FAX COVER SHEET

DATE: 7/31/01 TIME:
TO: Russ Bywater PHONE: 3113
Kathy Weaver FAX:
FROM: Woody Walker PHONE: 4923
FAX:
RE: Fire Protection related questions
cc:

Questions from NRC resident inspectors related to walkdown of Unit 1 Auxiliary building, elevations 354' and 335'.

Title: EVALUATE FIRE PROTECTION REQUIREMENTS IN FIRE ZONE 79-U

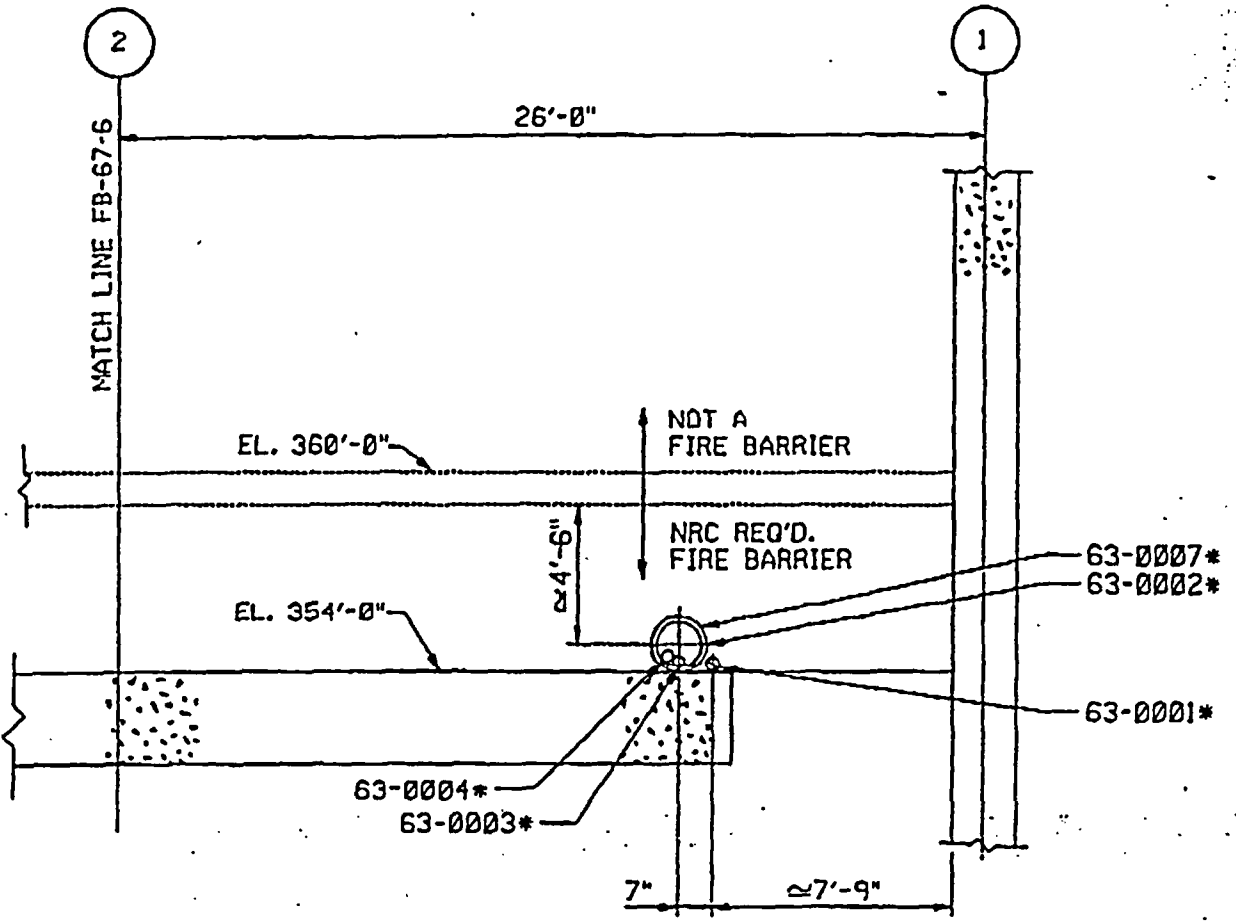
*not wrapped green
CWHOS*

*red
1405*
